Item Name: Crosstube Turning Detail

DART AEROSPACE LTD	Work Order:	72979
Description: Crosstube Assembly	Part Number:	D206-667-243
Inspection Dwg: D206-667-243 Rev: C		Page 1 of 1

DRAWING NO. D206-667-243	TITLE CROSSTUBE ASS'Y (206L HIGH AFT)	REV. C	DART AEROSPACE LTD ENGINEERING ORDER		D.E.O. NO. D206-667-243-C-1	SHEET NO. SHEET 1 OF 1	SCALE NTS
DRAWN <i>q</i>	CHECKED <i>ASS</i>	MFG. APPR. <i>RB</i>	APPROVED <i>MD</i>		DE APPR. <i>#</i>		
DATE 11.07.15	DATE 11.07.20	DATE 11.07.21	DATE 11/07/21		DATE 11.07.21

REPLACE MAGNOBOND WITH PROSEAL.

D206-667-243
ASSEMBLY DETAIL
(VIEW LOOKING FWD)

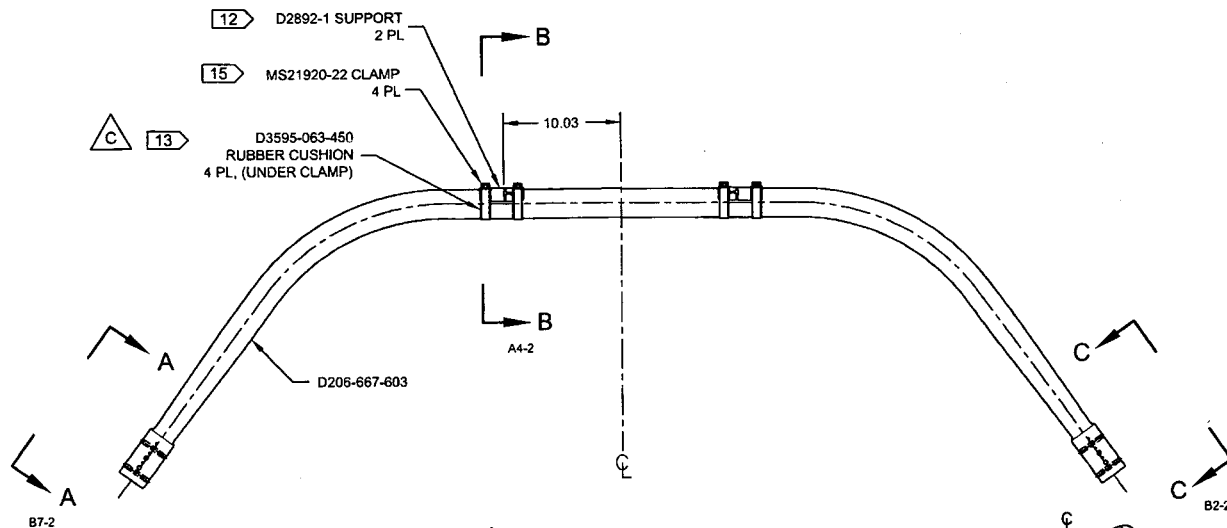
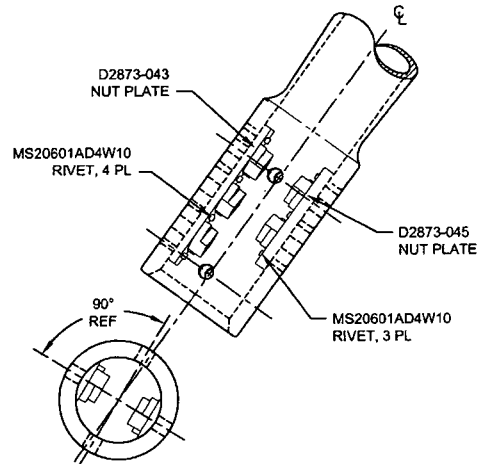
C	REVISE GENERAL NOTES/PART LIST (ZN D7-1); REORGANIZED VIEWS AND REFORMATTED DRAWING TO CURRENT STANDARDS. D3595-063-450 WAS D2856-400-773 (ZN D6-2 & A5-2); REMOVED REF. & ADD TOLERANCES (ZN 4-3, C5-3, D3-3); RELOCATED FLAG #6 (ZN A5-3) PER NCR 210; MOVED TURNING DETAIL & UPDATED TOLERANCE TO SHEET 4.	RF	08.11.06
B	ADD HOLES AND NUT PLATES FOR COMPATABILITY WITH BHT/AA SKUDTUBES	PH	05.07.26
A	NEW ISSUE	CP	00.11.17
REV.	DESCRIPTION	BY	DATE
DESIGN	RF	DART AEROSPACE LTD	
DRAWN	RF	HAWKESBURY, ONTARIO, CANADA	
CHECKED	RF	DRAWING NO.	REV. C
MFG. APPR.	RF	D206-667-243	SHEET 1 OF 4
APPROVED	RF	TITLE	SCALE
DE APPR.	RF	CROSSTUBE ASSY (206L HIGH AFT)	NTS
DATE	08.11.06	COPYRIGHT © 2000 BY DART AEROSPACE LTD THIS DOCUMENT IS PRIVATE AND CONFIDENTIAL AND IS SUPPLIED ON THE EXPRESS CONDITION THAT IT IS NOT TO BE USED FOR ANY PURPOSE OR COPIED OR COMMUNICATED TO ANY OTHER PERSON WITHOUT WRITTEN PERMISSION FROM DART AEROSPACE LTD.
